EXHIBITION OF PENNANT (GAY) STREET TARGET

SITE DRAFT DEVELOPMENT CONTROL PLAN

EXECUTIVE SUMMARY

Figure 7a. Indicative view from intersection of Old Northern Road and Pennant Street

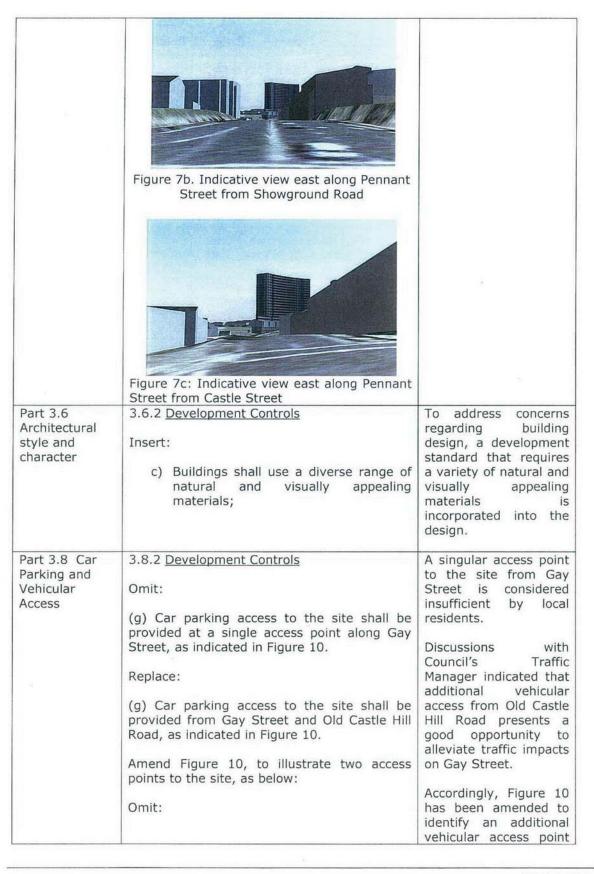
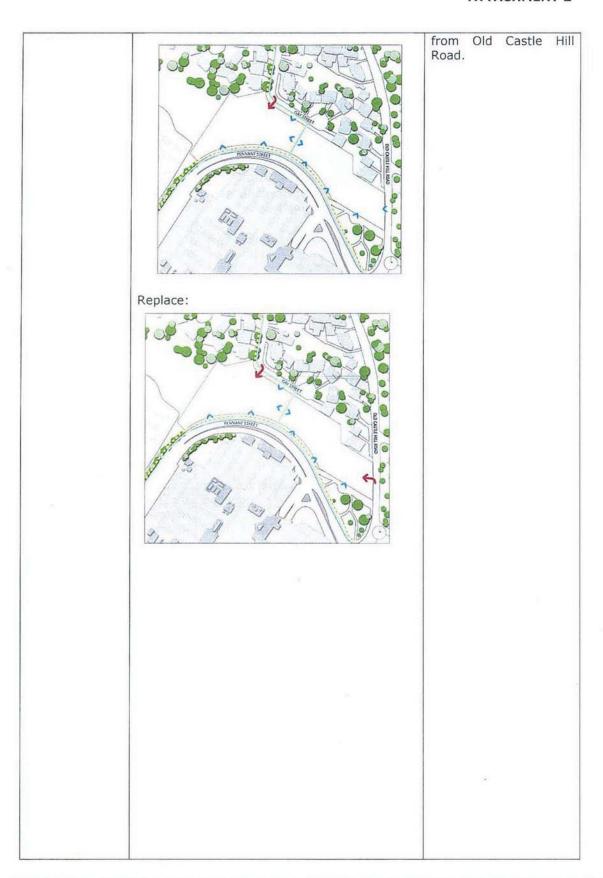
Remove the following images from the draft Plan:

Submissions received have identified that that the proposed development is visually unattractive. The images in the draft Plan are indicative only and will be removed from the plan.
